Access Compliance Report

Public Rights-of-Way

(Curb Ramps)

Intersection ID: 24573	Main Street: COACHFORD_CT	Cross Street: MALLOW_PL	Location: S
ADA ID: B53A8EE22406	Ramp Type: PerpDiag	Initial Pass/Fail: Fail	Overall Compliance: No
			Severity Score: 13.75

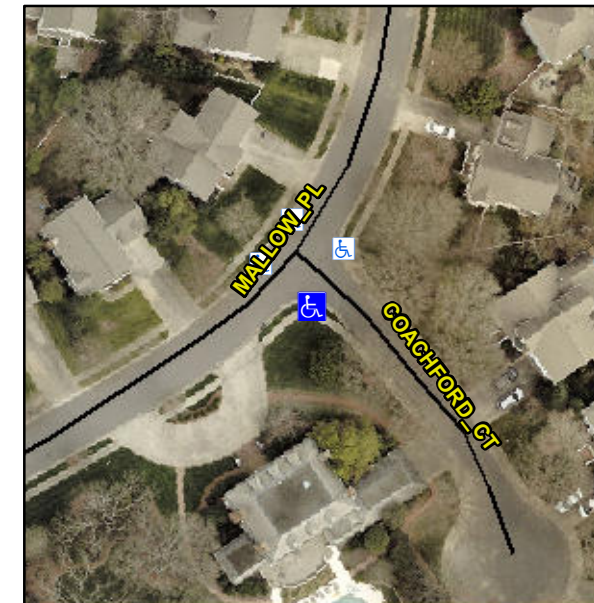
Not Found, R304.2.2, R304.5.3

Compliance	Description	Data	Compliance	Description	Data
N/A	Ramp Length (in)	48.0	No	Ramp Slope (%)	9.1
Yes	Ramp Width (in)	49.0	No	Ramp XSlope (%)	2.7
N/A	Flare Type LT	N/A	N/A	Flare Type RT	N/A
N/A	Flare Slope LT (%)	N/A	N/A	Flare Slope RT (%)	N/A
N/A	Flare Traversable LT?	N/A	N/A	Flare Traversable RT?	N/A
N/A	Landing Length (in)	N/A	N/A	DWS Provided?	N/A
N/A	Landing Width (in)	N/A	N/A	DWS Contrast?	N/A
N/A	Landing Slope (%)	N/A	N/A	DWS Length (in)	N/A
N/A	Landing X Slope (%)	N/A	N/A	DWS Full Width?	N/A
N/A	Landing Curb? (Y/N)	N/A	N/A	DWS Offset (in)	N/A
N/A	Shared Landing?	N/A			
N/A	Gutter Ponding?	N/A	N/A	Gutter Slope (%)	N/A
N/A	Gutter Lip Ht (in)	N/A	N/A	Gutter X Slope (%)	N/A
N/A	Painted X Walk1?	No	N/A	Painted X Walk2?	No
	X Walk 1 Direction	To NE		X Walk 2 Direction	To NW
N/A	X Walk 1 Width (in)	N/A	N/A	X Walk 2 Width (in)	N/A
	X Walk 1 Slope (%)	0.3		X Walk 2 Slope (%)	1.4
	X Walk 1 X Slope (%)	0.9		X Walk 2 X Slope (%)	0.5

Remove & Replace Curb Ramp With Two New Directional Ramps or Equivalent.
